Docket Nos. 50-277
and 50-278

PEACH BOTTOM ATOMIC POWER STATION, UNIT NO. 2

Amendment No. 61
License No. DPR-44

ATTACHMENT TO LICENSE AMENDMENT NO. 61

Figure 6.2-2

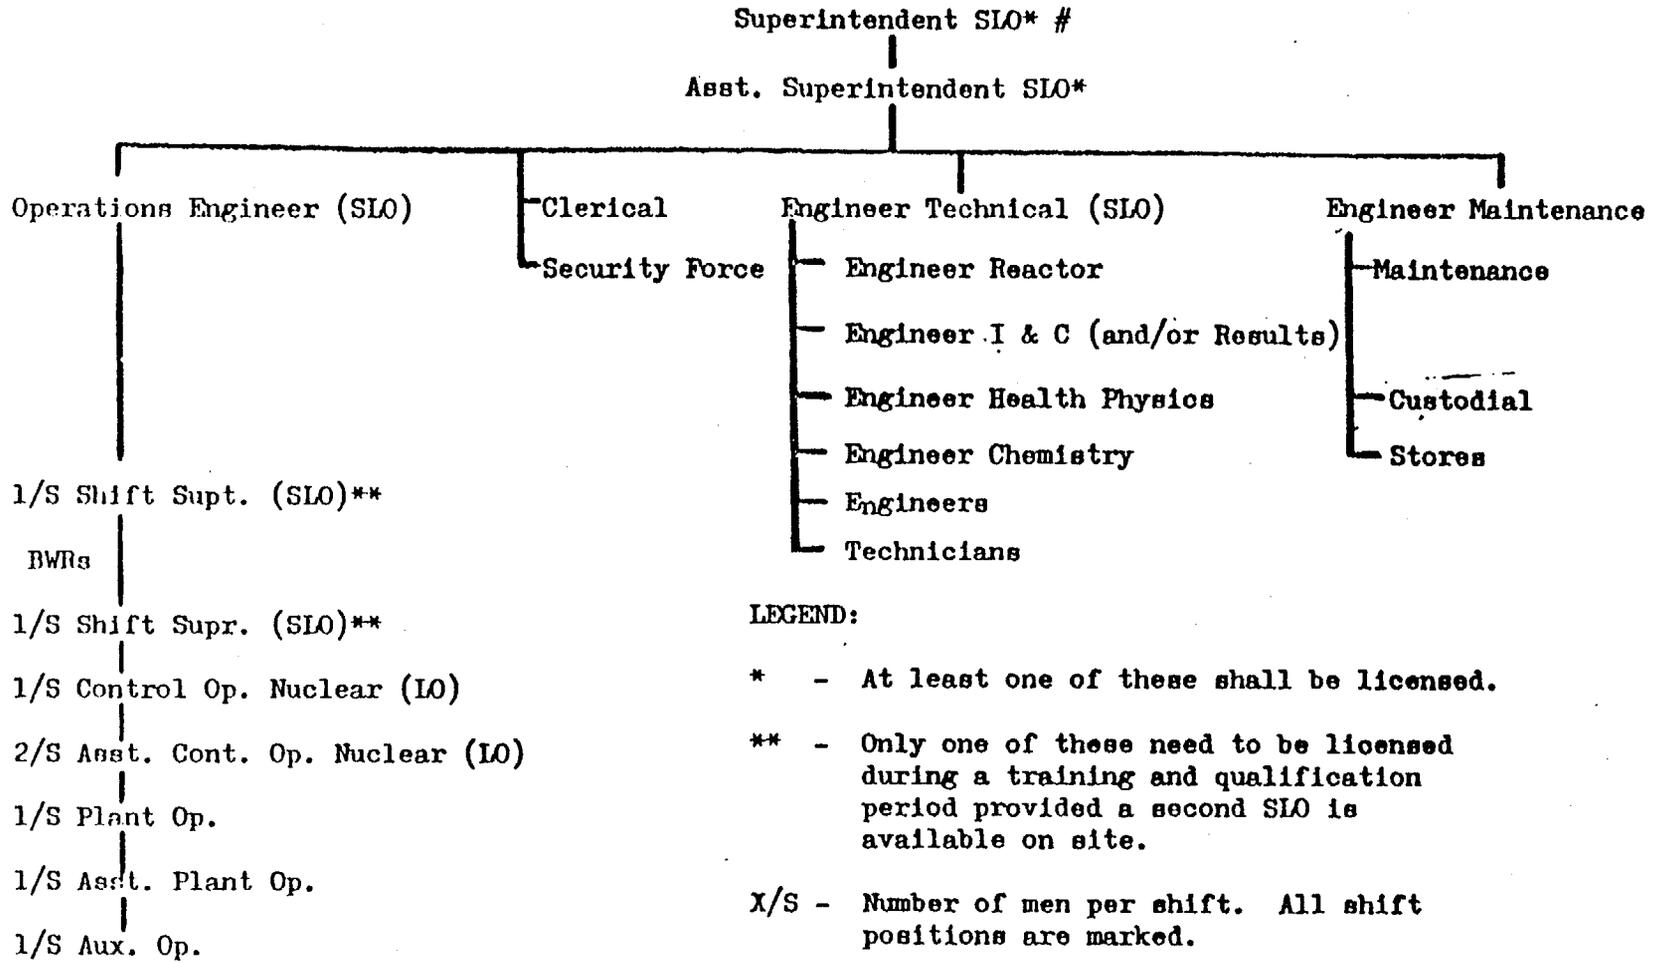
The substantive changes to the membership of the Plant Operations Review Committee and the figure depicting the Organization for Conduct of Plant Operations involves the separation of health physics responsibilities from the chemistry responsibilities and placing these under separate supervision. We were advised of this reorganization by your letter dated January 4, 1978. Since the proposed changes do not involve changes to the qualifications or functions of the Committee or of the operating staff, they are pro forma in nature and are acceptable.
